**EDWIN I. HATCH NUCLEAR PLANT, UNIT NOS. 1 AND 2
REQUESTS FOR ADDITIONAL INFORMATION (RAIs),
FOURTH 10-YEAR INTERVAL INSERVICE INSPECTION PROGRAM**

EDWIN I. HATCH NUCLEAR PLANT, UNIT NOS. 1 AND 2
REQUESTS FOR ADDITIONAL INFORMATION (RAIs),
FOURTH 10-YEAR INTERVAL INSERVICE INSPECTION PROGRAM

Response to RAIs Contained in NRC letter of October 5, 2010
ISI-RR-02, ISI-RR-06, and ISI-RR-07

Response to RAIs Contained in NRC letter of October 22, 2010
ISI-RR-03, ISI-RR-04, ISI-RR-05, ISI-RR-08,
ISI-RR-09, ISI-RR-10, and ISI-RR-11

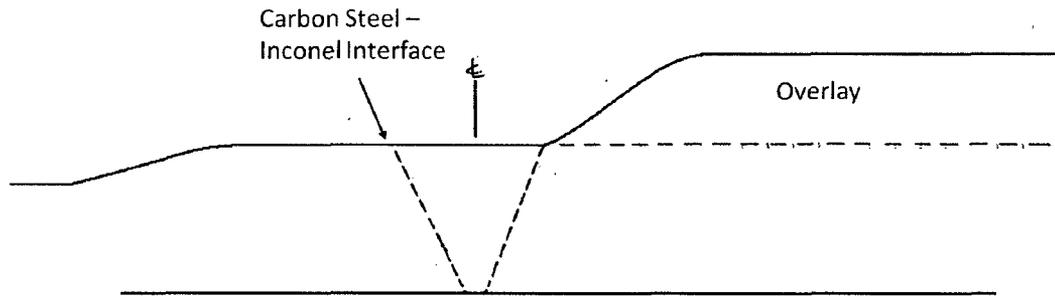
Please provide a more legible copy of Figure 1 on page 4 of 5.

Relief Request RR-47, dated July 10, 2006, reports 75% coverage on this same weld when it was examined prior to the implementation of Appendix VIII and the Performance Demonstration Initiative (PDI) Program. The total coverage for this weld exam included examination from the Inconel side of the weld, through the weld overlay. Specifically, the examination through the weld overlay was performed using an automated system utilizing a 60-degree refracted longitudinal wave search unit. No limitations due to the overlay were noted in the relief request. Additionally, no unacceptable indications in the weld were reported. In light of the apparent successful examination of the required weld volume (lower 1/3T) through the weld overlay in the 3rd 10-Year ISI interval, please justify the omission of this (supplemental) exam for 4th 10-year ISI interval. The NRC understands that there are currently no PDI-qualified techniques to perform the examination of the lower 1/3T through a weld overlay.

Please explain why the weld overlay does not cover weld 2B21-1FW-12AA-8.

Figure 1 was replaced by a new Figure 1, as shown below.

As depicted in revised Figure 1, the configuration for weld 2B21-1FW-12AA-8 consists of a tapered area to the left side of the weld, a relatively flat area from the taper to overlay, and a full-structural weld overlay over adjacent weld 2B21-1FW-12AA-9. The 3rd 10-Year ISI interval examinations were performed prior to Appendix VIII, Supplement 10 requirements which were not required to be met until November 22, 2002. These pre-Appendix VIII examinations met requirements of the 1989 Edition of Section XI (no addenda). Scans were performed from the tapered area to the left side of the weld, from the flat surfaces, and from the overlay side of the weld. The only area not scanned was the overlay taper.

Weld 2B21-1FW-12AA-9 was overlaid in 1991 after indications were found during the non-destructive (NDE) examination. Adjacent weld 2B21-1FW-12AA-8 was not overlaid because:
